**Re: Letter of Notification of Duquesne Light Company for Approval to Reconfigure Existing and Construct New 138 kV Transmission Lines in Allegheny County, Pennsylvania
Docket No. A-2018-3002896**

**Bureau of Technical Utility Services
Data Requests to Duquesne Light Company**

Docket No. A-2018-3002896

REVISED
ATTACHMENT 4

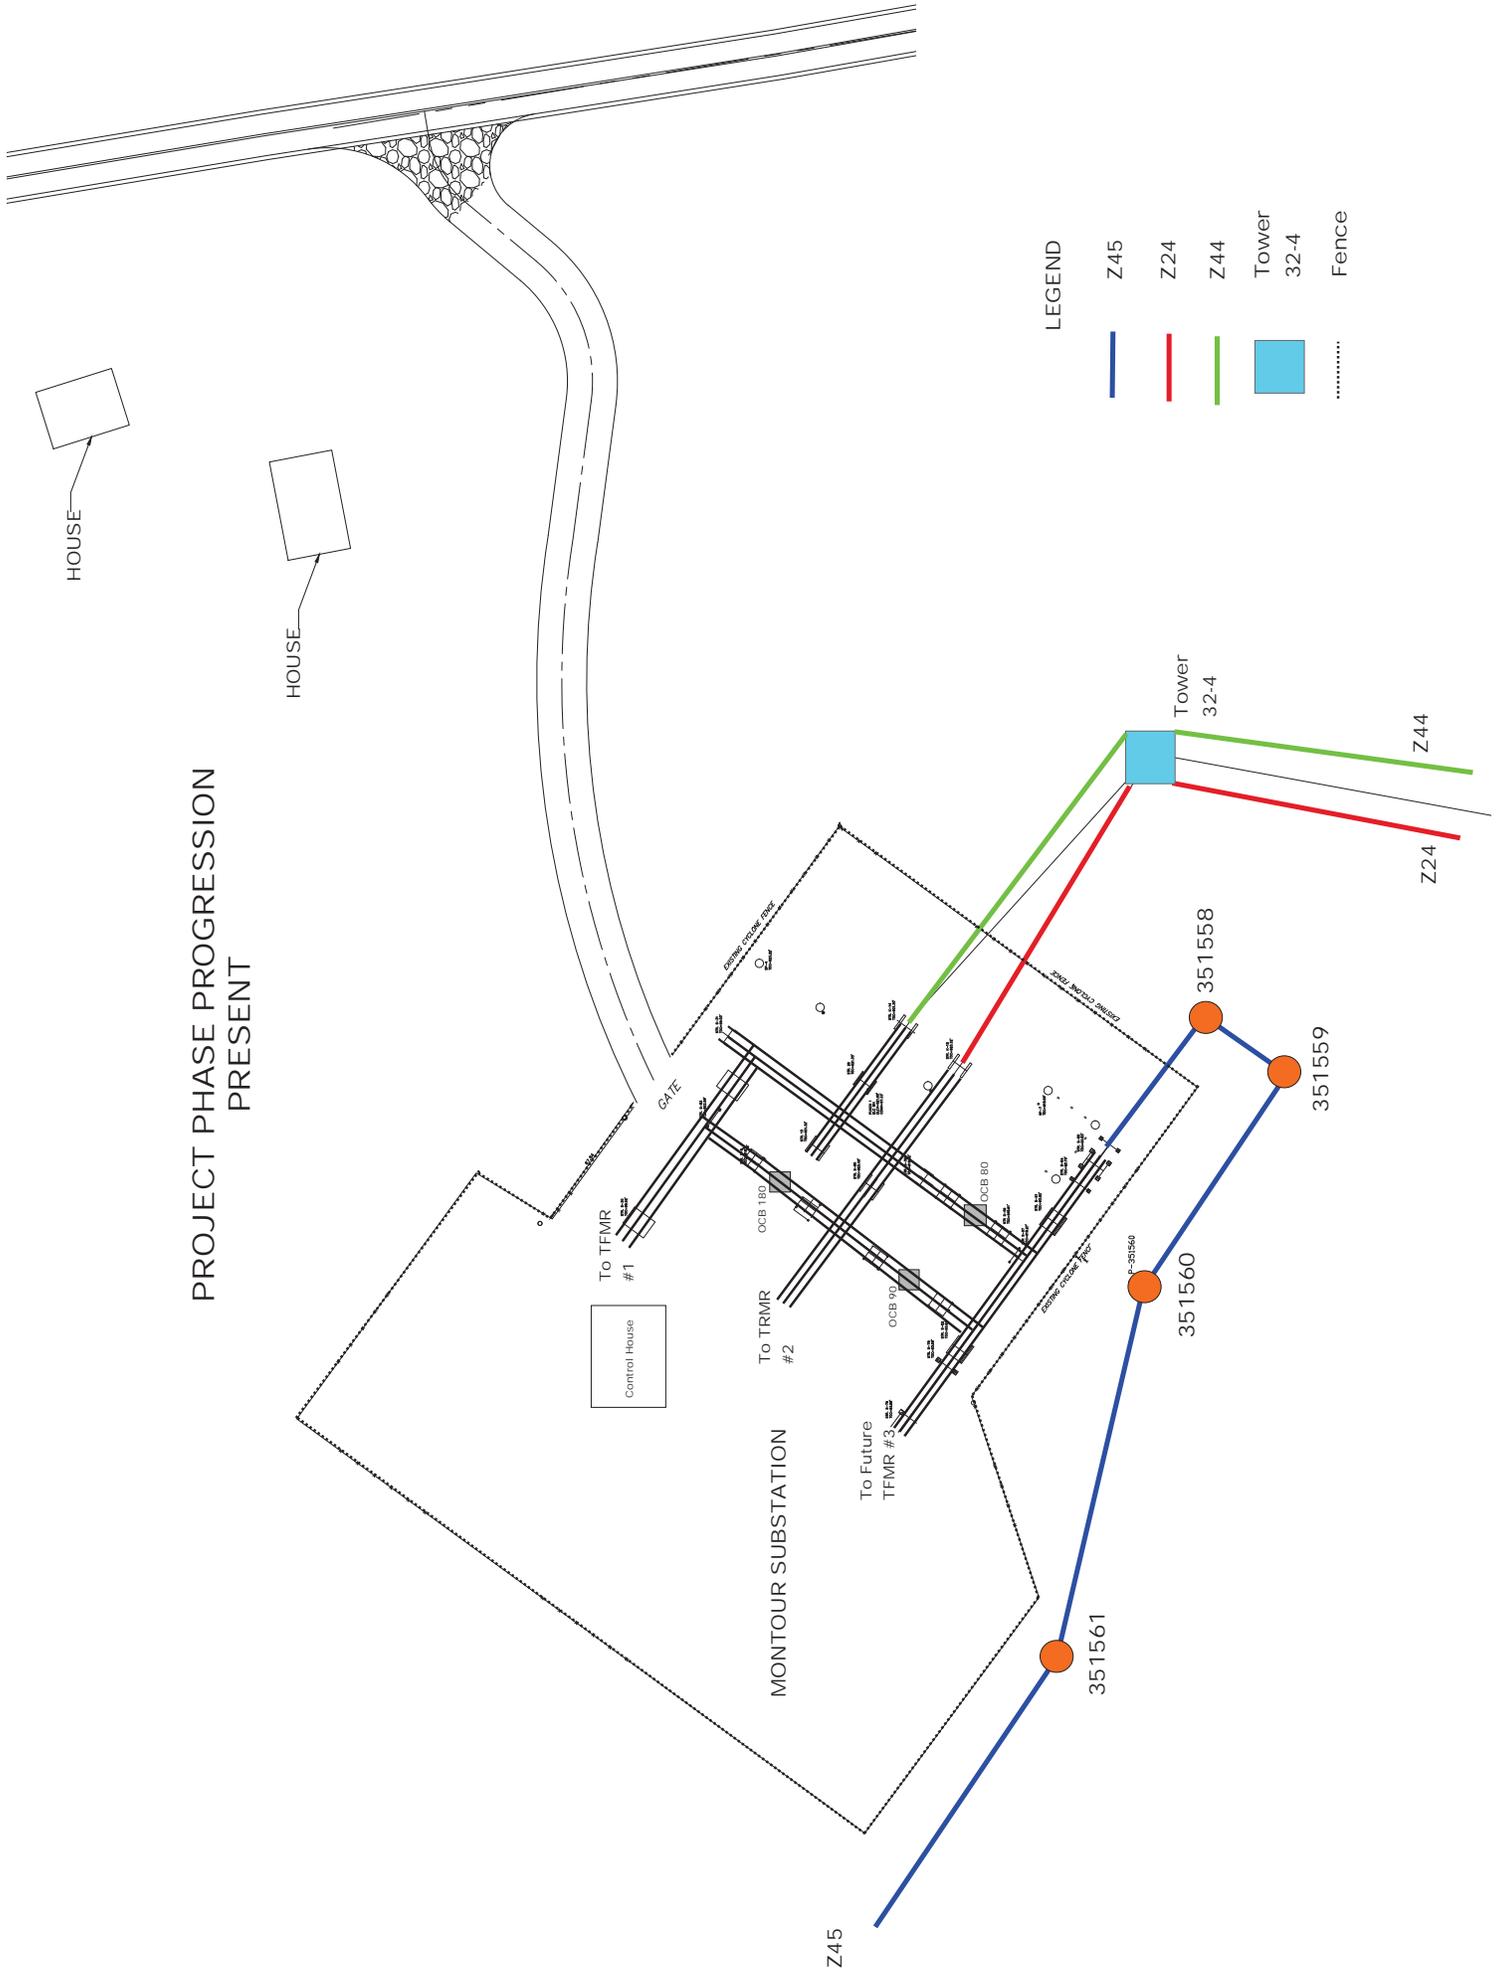
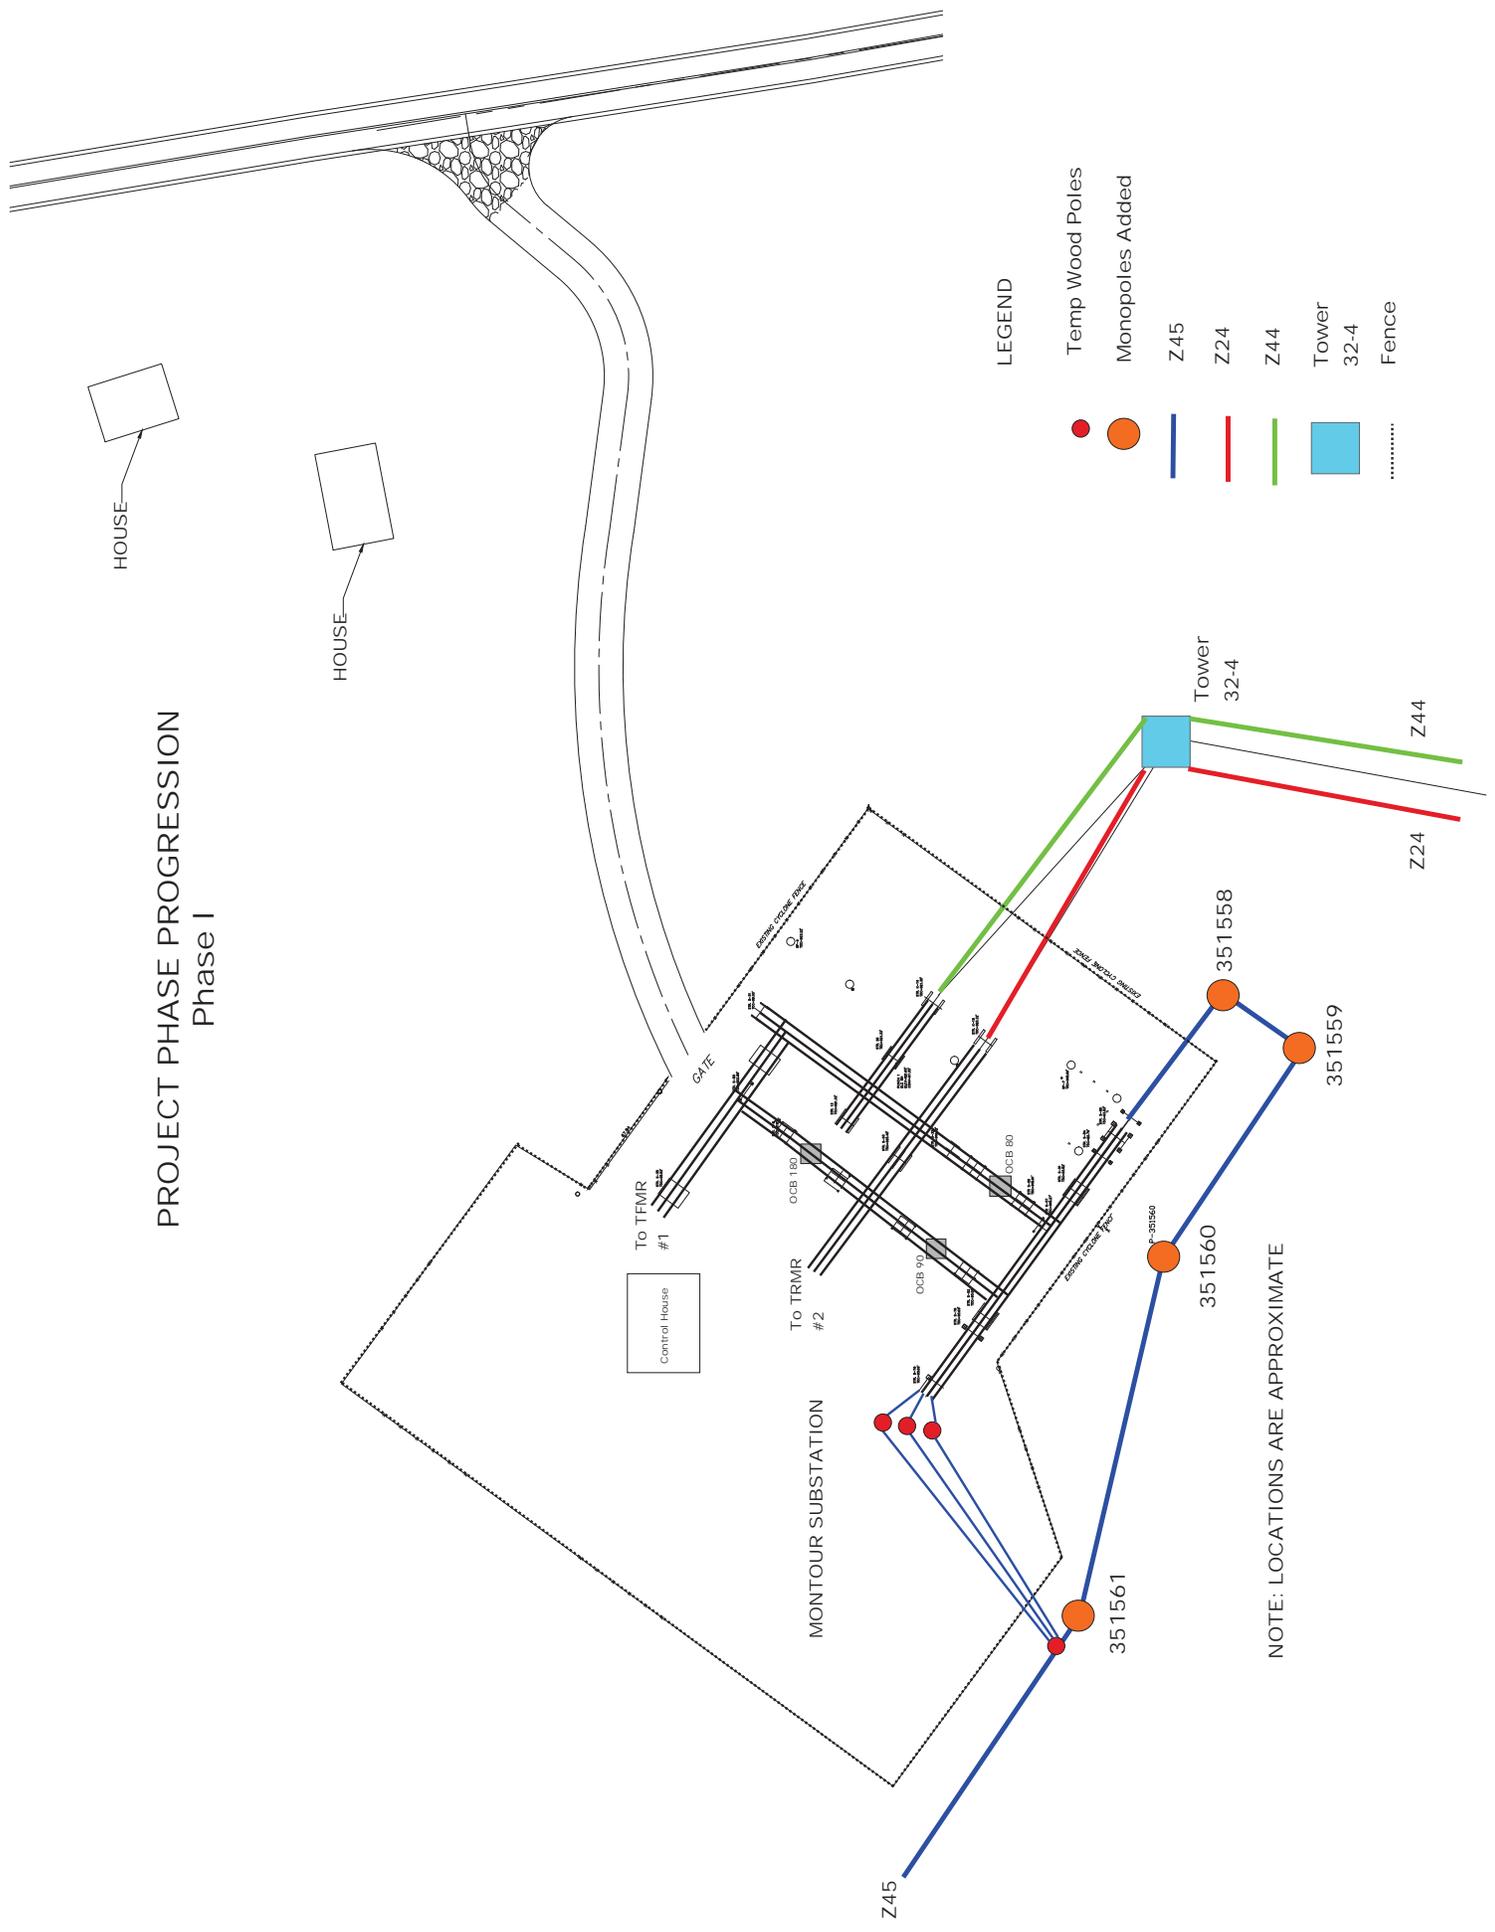
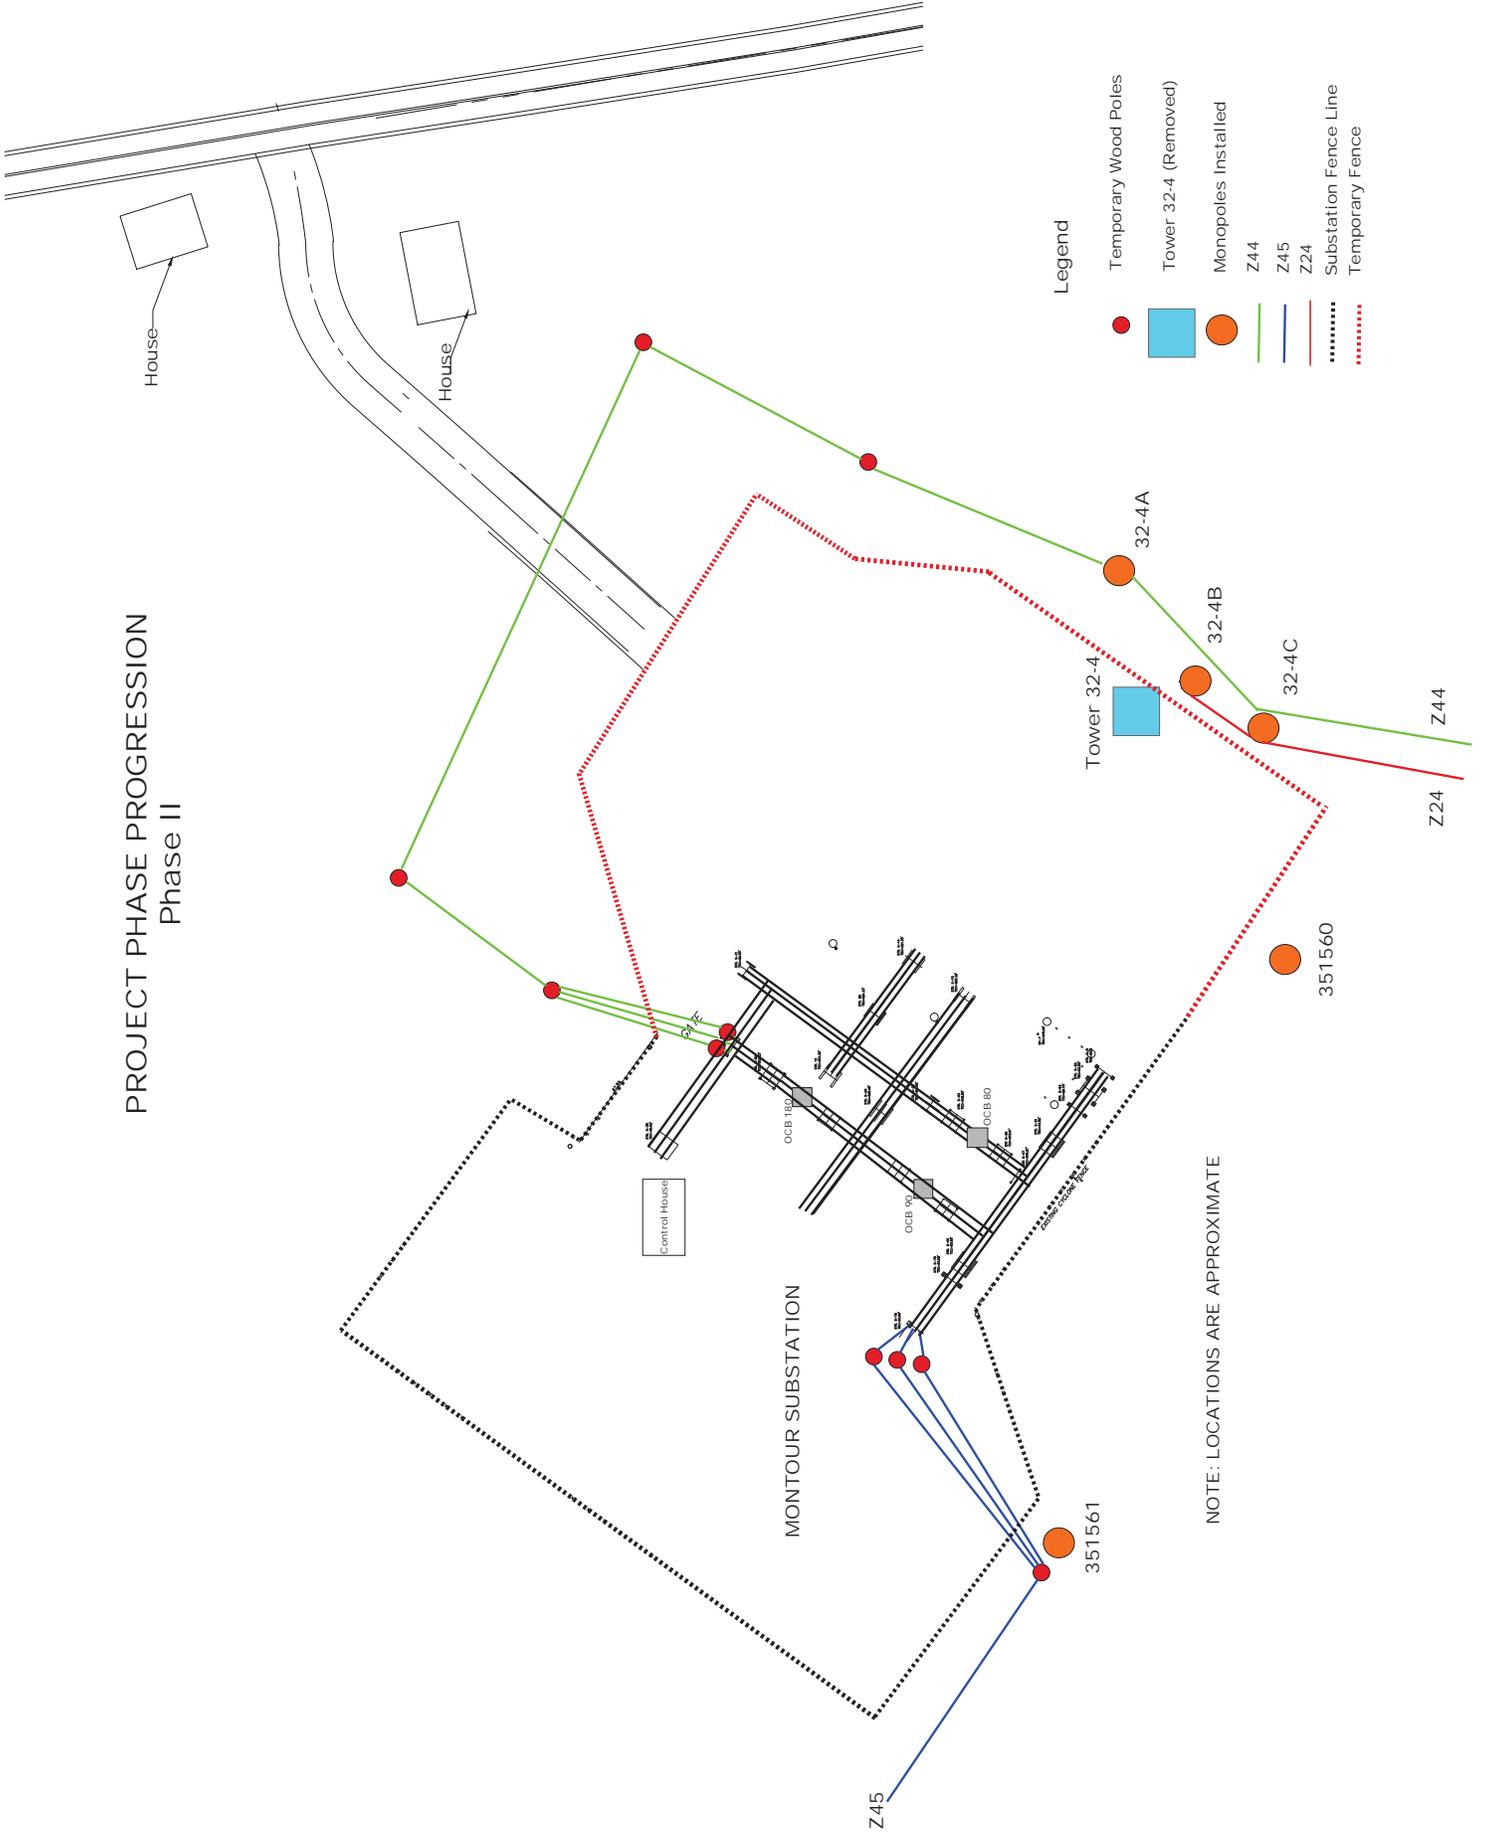
A-6 Reference the Letter of Notification, Section III(B). Please state the height of the new temporary and permanent transmission line structures to be installed.

The following permanent transmission line structures will be installed as part of the proposed project. Included in this response is a revised Attachment 4, which corrects a typographical error that inadvertently omitted the “5” from the “351560” permanent monopole.

Permanent Transmission Line Monopoles	Proposed Height of Monopoles
351560 New	75 ft
351561 New	80 ft
32-4A New	70 ft
32-4B New	80 ft
32-4C New	95 ft
